**Production Discontinuation of CC-Link Remote I/O Station Communication LSIs
in September 2025**

A6GA-CCMFP2ANN60FN and A6GA-CCMFP2ANN300FN

FA-A-0441-A

6.1 Appearance and Print

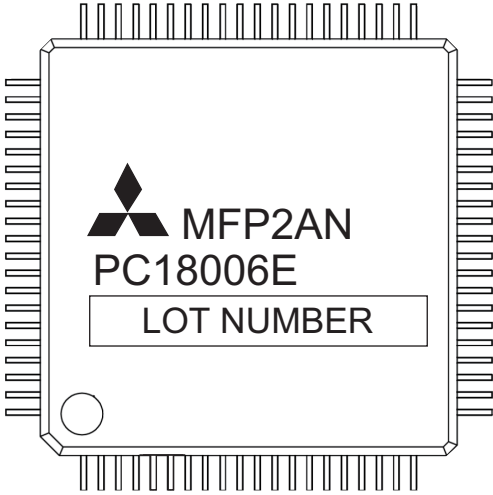
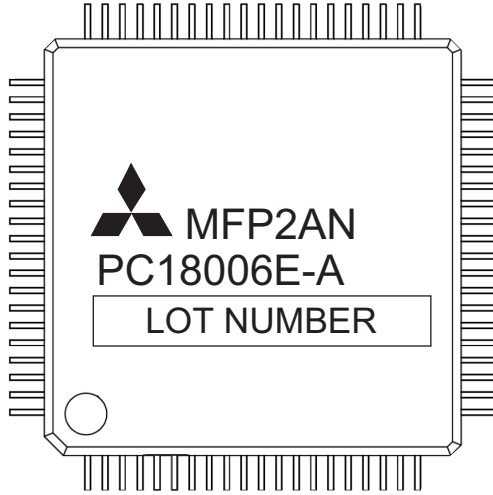
The alternative models differ from the discontinued models in external dimensions and printing.

There is no difference in electrical characteristics.

Symbol	Model to be discontinued (PC18006E)			Alternative model (PC18006E-A)			Unit
	Min.	Normal	Max.	Min.	Normal	Max.	
E	11.90	12.00	12.10	11.90	12.00	12.10	mm
D	11.90	12.00	12.10	11.90	12.00	12.10	mm
A	—	—	1.20	—	—	1.70	mm
A ₁	0.00	0.10	0.20	0.00	0.10	0.20	mm
A ₂	0.90	1.00	1.10	1.30	1.40	1.50	mm
e	—	0.50	—	—	0.50	—	mm
b	0.17	0.22	0.27	0.13	0.20	0.27	mm
C	0.09	0.15	0.20	0.09	0.15	0.20	mm
θ	0	3	8	0	5	10	°
L	0.30	0.50	0.75	0.30	0.50	0.75	mm
L ₁	0.80	1.00	1.20	0.80	1.00	1.20	mm
H _E	13.60	14.00	14.40	13.60	14.00	14.40	mm
H _D	13.60	14.00	14.40	13.60	14.00	14.40	mm
x	—	—	0.08	—	—	0.08	mm
y	—	—	0.08	—	—	0.08	mm
